Reference: Casadonti Subdivision, Preliminary Plan Review 3

Pursuant to your request, Gilmore & Associates, Inc. has reviewed the revised Preliminary Plan submission for the above-referenced project and offers the following comments for consideration:

- A. Preliminary and Final Land Development and Minor Subdivision Plans for 140 Upper Church Road, as prepared by Holmes Cunningham, LLC, consisting of ten (10) sheets, dated June 16, 2023 last revised February 19, 2025.
- B. Post Construction Stormwater Management Plan Narrative for 140 Upper Church Road, as prepared by Holmes Cunningham, LLC, dated June 16, 2023, last revised August 19, 2024.
- C. Waiver Request Letter for 140 Church Road, as prepared by Holmes Cunningham, LLC, dated June 20, 2023, last revised March 14, 2024.
- D. Review Response Letter for 140 Church Road, as prepared by Holmes Cunningham, LLC, dated February 19, 2025.

140 UPPER CHURCH ROAD

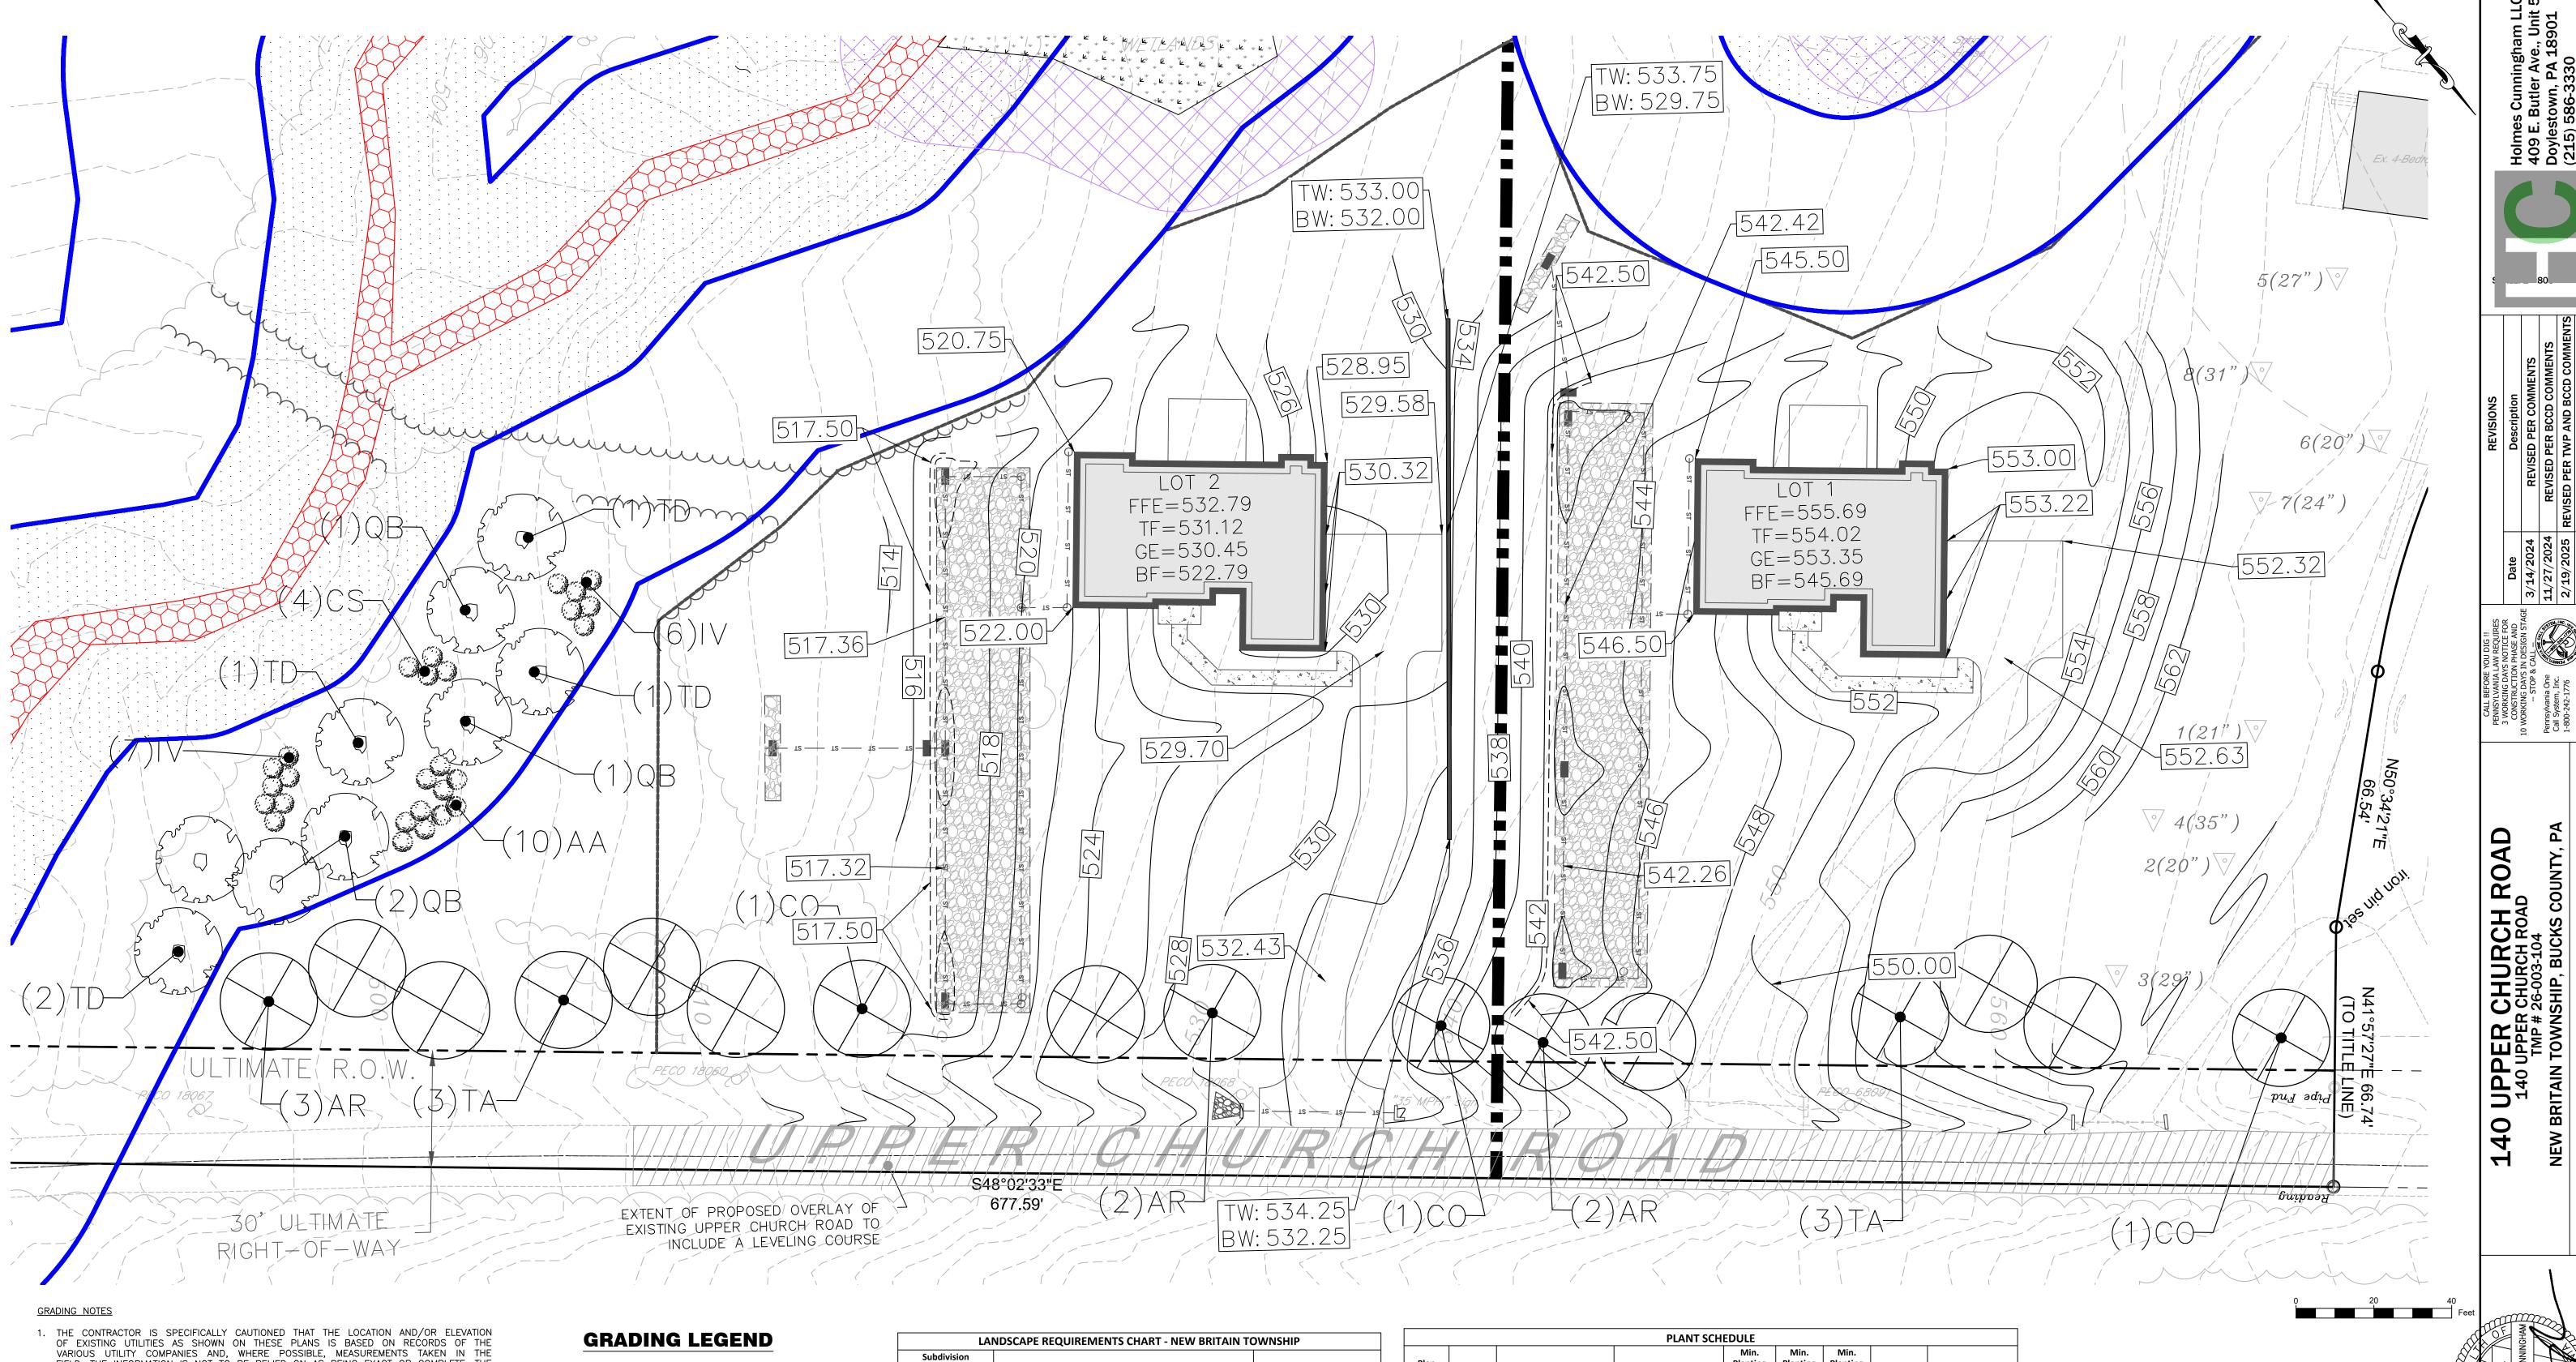
- 2. §22-502.B. The following comments related to the plans shall be addressed:
 - a. All requested/granted waivers should be noted on the Subdivision Plan.

- b. The H14 Accessory Dwelling use should only be specified for Lot 1 on the Zoning Data Table.
 - c. The curve information along the northern property boundary of Lot 1 should be added to the Subdivision Plan.

- d. A monument should be added at the change in direction of the Conservation Easement on Lot 2, adjacent to the stormwater facility, between lines with the bearings of S86°54'19"W and N86°07'39"W.

- e. Site Plan Note 10 on the Subdivision Plan specifies the ultimate right-of-way to be offered as an easement. This note should be revised to offer the area between the title line and ultimate right-of-way for dedication to New Britain Township.

- f. A note should be added to the Lot Area and Coverage Table requiring all future impervious to drain to the on-lot stormwater BMP unless otherwise approved by the Township.

- g. Existing features to be removed should not be shown on the Subdivision Plan.
- 3. §22-502.B.11 Legal descriptions are required for the new lots, conservation easements, ultimate right-of-way for Upper Church Road, back up septic system easements and any other proposed easements.

<u> </u>
File I	No.			
1890	O_CO.:	3 GRAI	DING.I	DWG
1890	023	20'	RC	10
Ħ	06/16/2023	1"=20		of
q	90		pət	4
HCE Job	Date	Scale	Designed	Sheet

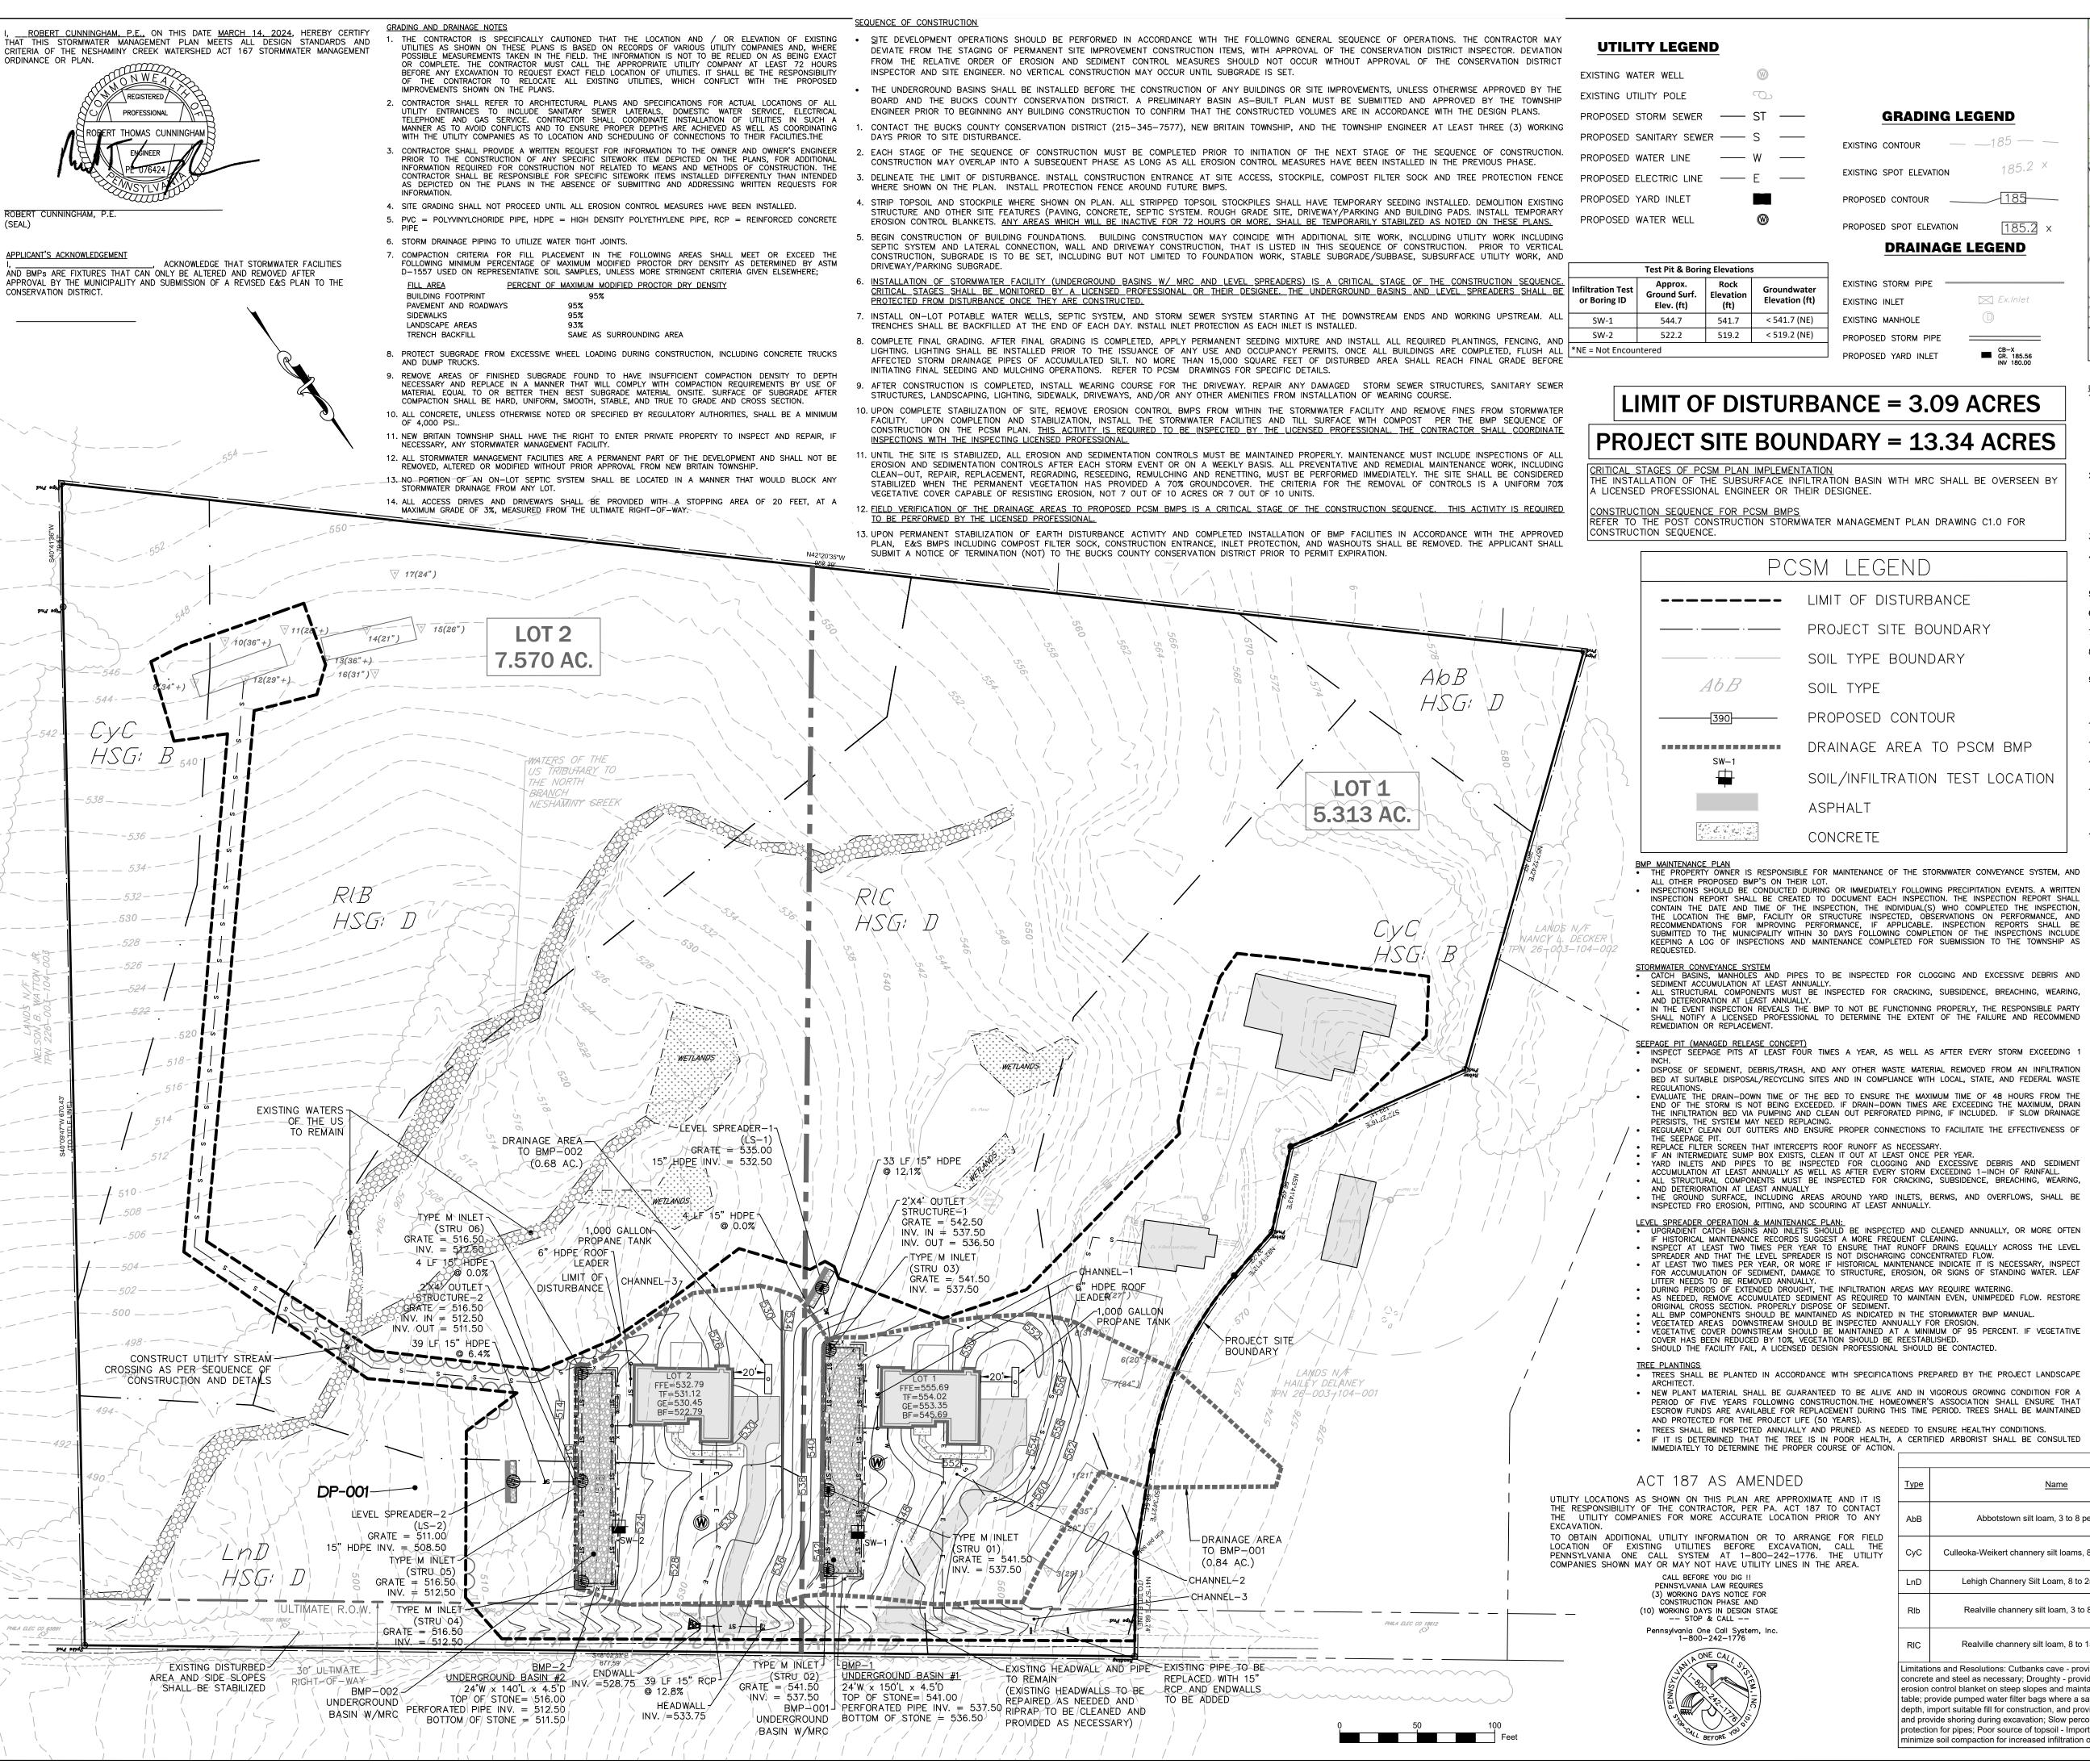
- 7. §22-711.3 The following comments related to grading shall be addressed:
 - a. Based on the proposed 534 contour and the 533.00 top of wall elevation on Lot 2, there appears to be a slope of 1:1 along the retaining wall. The grading should be revised to provide a maximum slope of 3:1.

- b. The proposed 529.58 spot elevation appears to represent the low spot of the driveway for Lot 2 which is a 1% slope across the yard to the proposed 528 contour at the rear of the dwelling. The grading should be revised to provide a minimum slope of 2% across all lawn.

- c. The storm sewer structures labels shall be shown on the Grading Plan.
 - d. The dashed contours around the stormwater facility inlets on Lot 2 appear to be an elevation of 517 and should be labeled.

OUTLET STRUCTURE-1 DETAIL

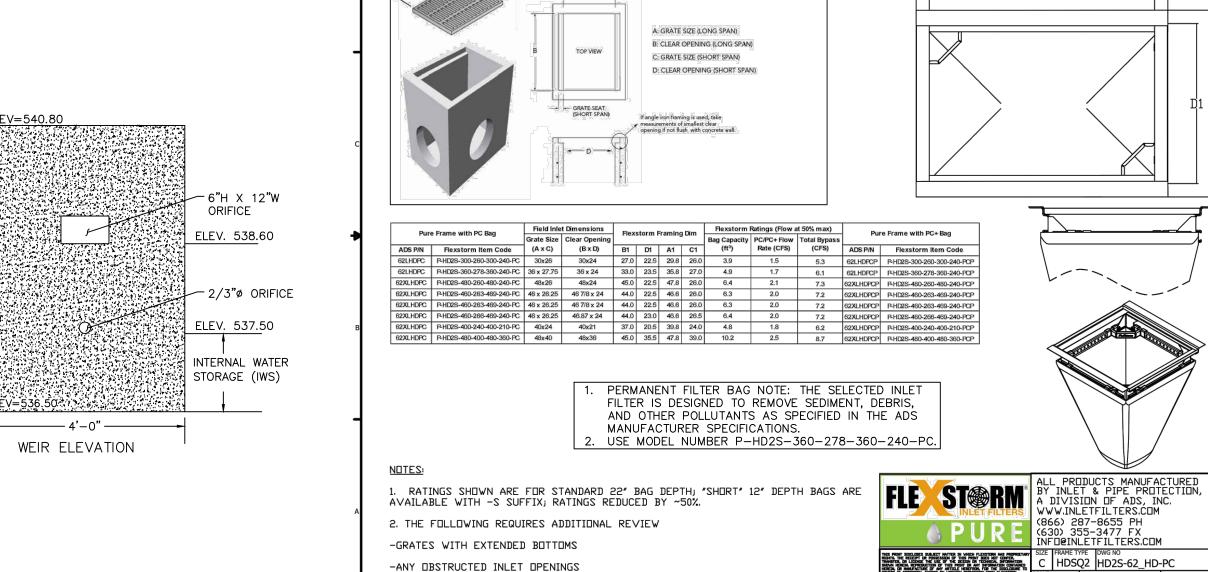
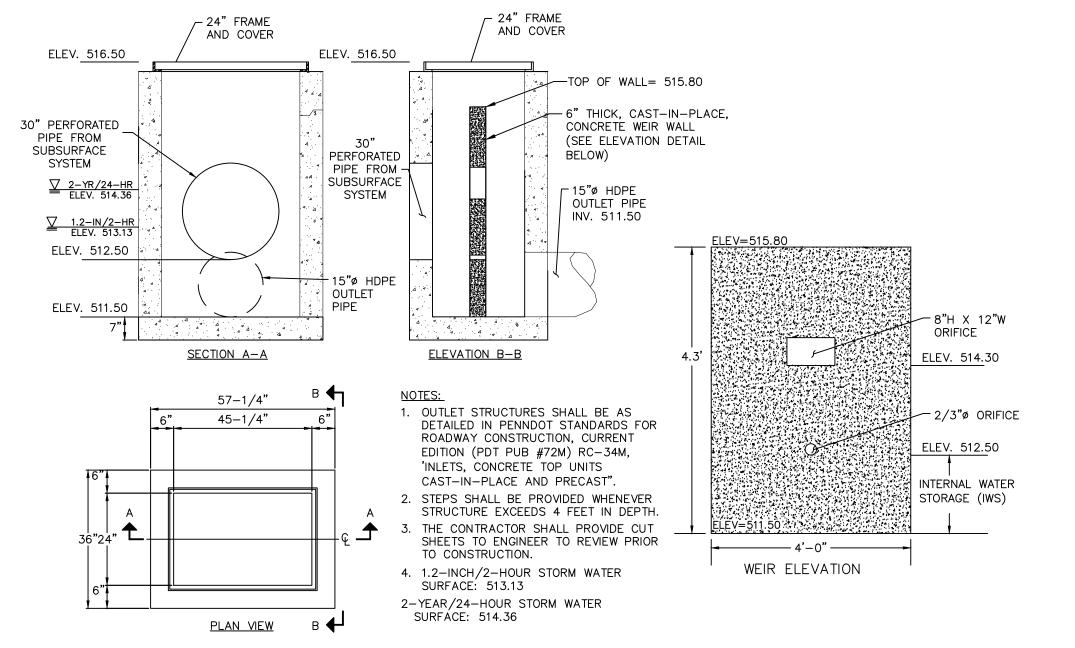
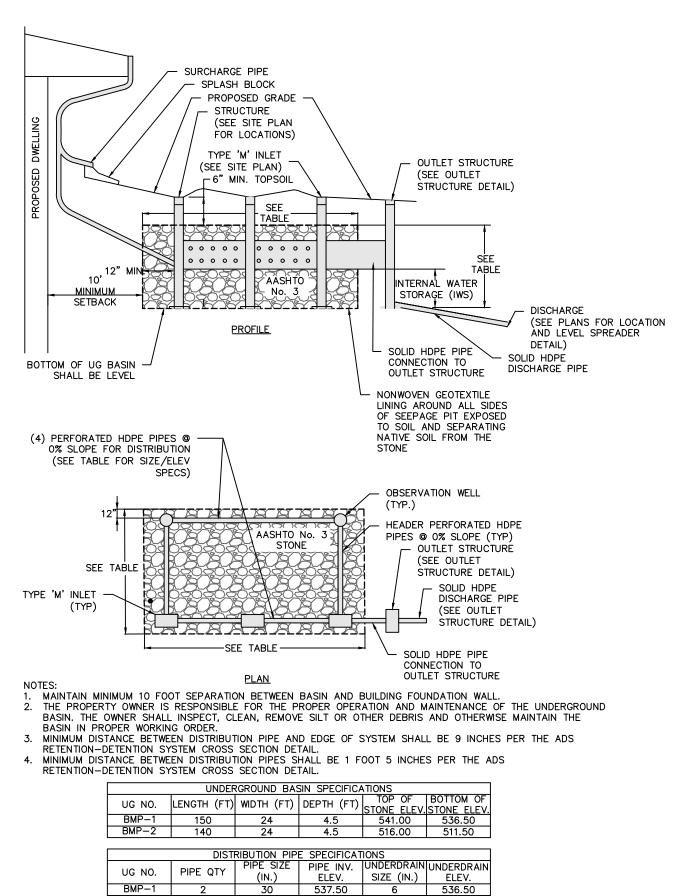
- 3. §26-125.9 The following comments related to the underground basins shall be addressed:
 - a. The plan proposes a 15" pipe between the stormwater facilities on Lots 1 and 2 and the outlet structures. This is not consistent with the Underground Basin Outlet Structure Details which specifies a 30" HDPE connection. The size of the pipe should be clarified.

- b. The plans propose the connection of 30" HDPE into the sides of standard inlet boxes which exceeds the inside width of these structures. A larger inlet box should be specified.

- e. The Underground Basin Outlet Structure Details specify a 4-foot-wide weir wall and model a 4-foot weir wall in the stormwater report. The proposed outlet structure uses a standard inlet box which only has a width of 3.77 feet. The width of the weir wall should be revised to match the width of the inlet structure.
